# UNITED STATES PATENT AND TRADEMARK OFFICE

10/622,150

<b>Office Action Summary</b>	<b>Application No.</b> 10/622,150	<b>Applicant(s)</b> COURCY, MATTHEW LOUIS	
	<b>Examiner</b> Howard L. Williams	<b>Art Unit</b> 2819

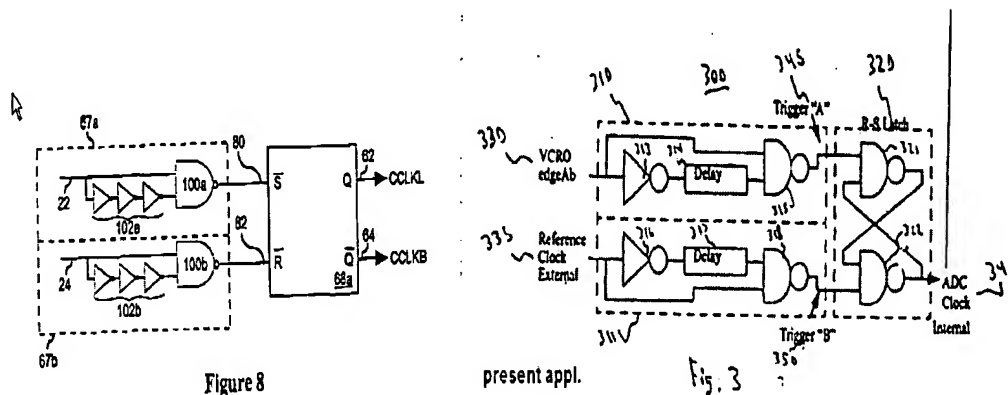
Stark in figure 8 discloses: edge detectors (67a & 67b) and latch/S-R flip flop (66a).

Stark's figure 8 (on the left above) has the same configuration as figure 3 of the present application since the inverters 102a and 102b provide delay circuits. The inputs (22, 24) to the Stark edge detectors are complementary clock signals and 180 degrees out of phase. In the terms of signal period and duty cycle would be one-half clock period delayed phase. Stark's circuit also inherently provides an output clock that is independent of the duty cycle of the input given the similar construction of the circuit to that of Eitrheim et al. (see below)

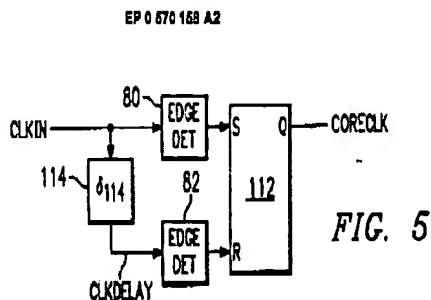
Eitrheim et al. in figure 5 discloses a clock generation circuit that includes an

edge detector 80, conditioning circuit 114 and an R-S latch. Eitrheim also discloses that the clock output ("CORECLK" in the figure) is independent of the duty cycle of the input clock (abstract and col. 11, line 31).
